# Access Compliance Report

## Public Rights-of-Way

### (Curb Ramps)

Intersection ID: 10032503	Main Street: N_CALDWELL_ST	Cross Street: N/A	Location: N
ADA ID: BDAC354631BC	Ramp Type: Perp	Initial Pass/Fail: Fail	Overall Compliance: No
Severity Score: 25			
Codes/Mitigation Info/Possible Solution		Field Measurements/Component Compliance

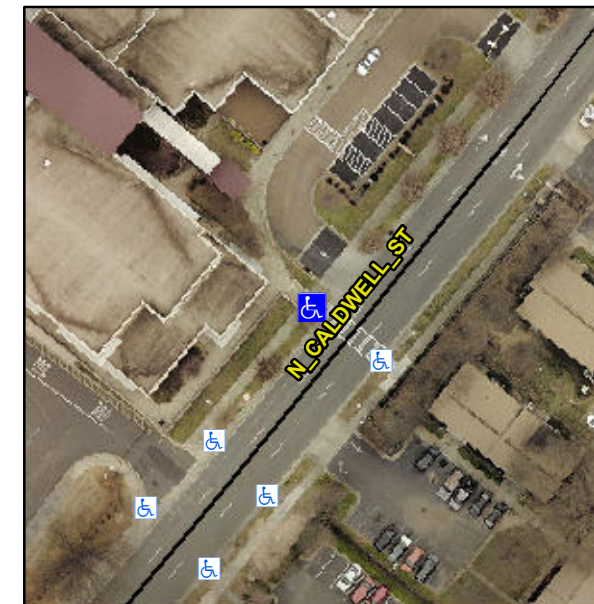
**Not Found, R304.2.2**

Compliance	Description	Data	Compliance	Description	Data
N/A	Ramp Length (in)	71.0	No	Ramp Slope (%)	13.5
Yes	Ramp Width (in)	62.0	Yes	Ramp XSlope (%)	0.9
N/A	Flare Type LT	N/A	N/A	Flare Type RT	N/A
N/A	Flare Slope LT (%)	N/A	N/A	Flare Slope RT (%)	N/A
N/A	Flare Traversable LT?	N/A	N/A	Flare Traversable RT?	N/A
N/A	Landing Length (in)	N/A	N/A	DWS Provided?	N/A
N/A	Landing Width (in)	N/A	N/A	DWS Contrast?	N/A
N/A	Landing Slope (%)	N/A	N/A	DWS Length (in)	N/A
N/A	Landing X Slope (%)	N/A	N/A	DWS Full Width?	N/A
N/A	Landing Curb? (Y/N)	N/A	N/A	DWS Offset (in)	N/A
N/A	Shared Landing?	N/A			
N/A	Gutter Ponding?	N/A	N/A	Gutter Slope (%)	N/A
N/A	Gutter Lip Ht (in)	N/A	N/A	Gutter X Slope (%)	N/A
N/A	Painted X Walk1?	Yes	N/A	Painted X Walk2?	N/A
	X Walk 1 Direction	To SE		X Walk 2 Direction	N/A
N/A	X Walk 1 Width (in)	111.0	N/A	X Walk 2 Width (in)	N/A
	X Walk 1 Slope (%)	2.3		X Walk 2 Slope (%)	N/A
	X Walk 1 X Slope (%)	1.4		X Walk 2 X Slope (%)	N/A

**Remove & Replace Entire Ramp.**
